September 15, 2010

Project No. 2008-007

Subject: Addendum No. 1
Preliminary Materials Report
Grove Avenue Corridor Project
Project No. ST0302
Ontario, California

Figure 1 - PAVEMENT THICKNESS RECOMMENDATIONS - GROVE AVENUE AND FOURTH STREET

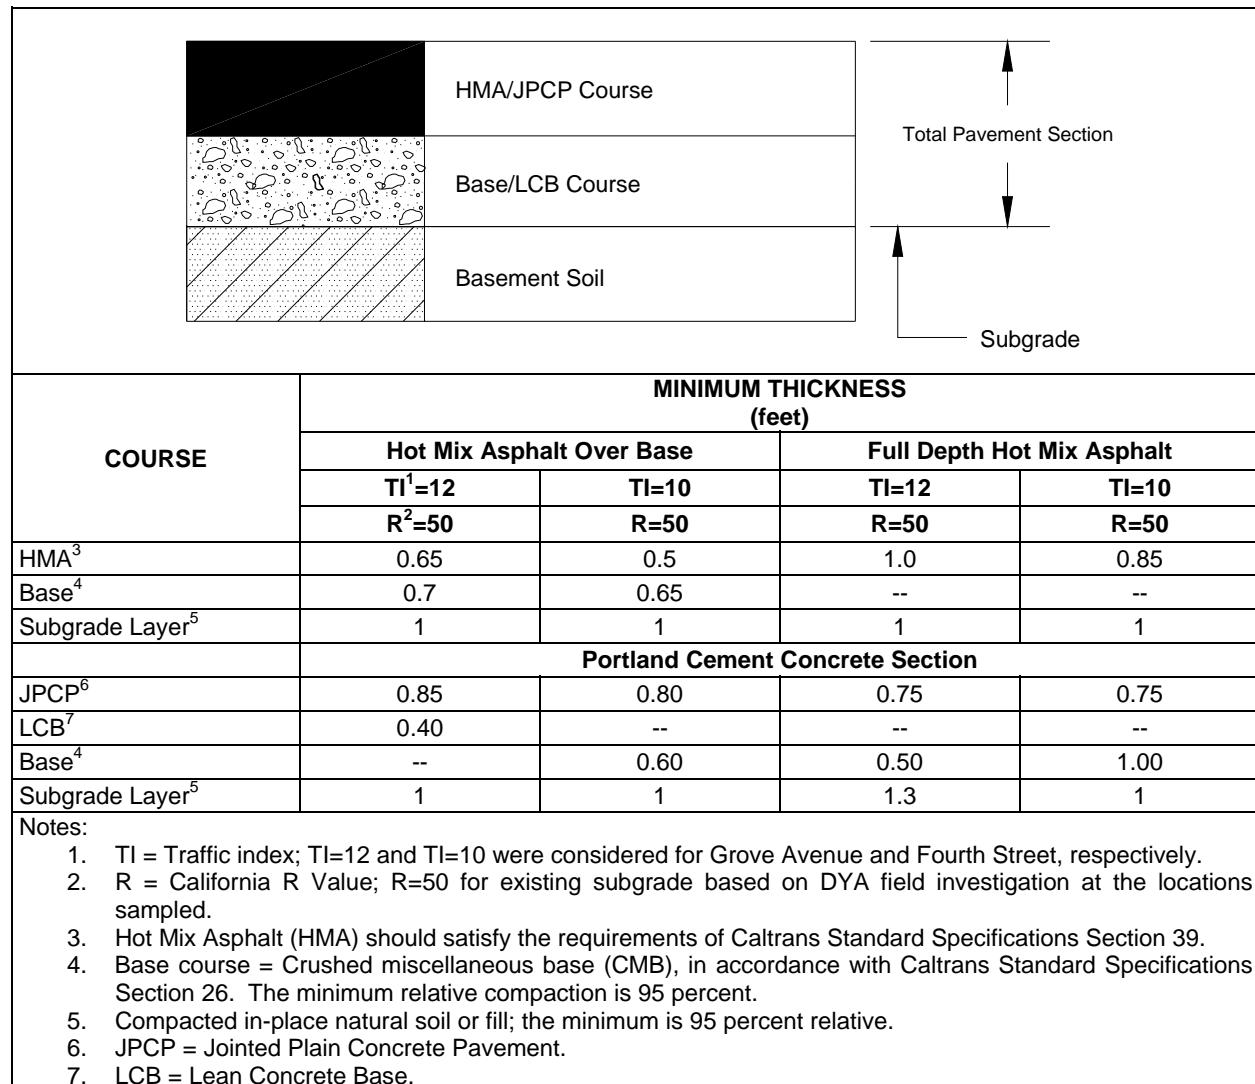
The revised pavement recommendations for Grove Avenue and Fourth Street are provided on Figure 1. Recommendations for freeway pavement sections based on assumed subgrade characteristics are included on Figure 2.
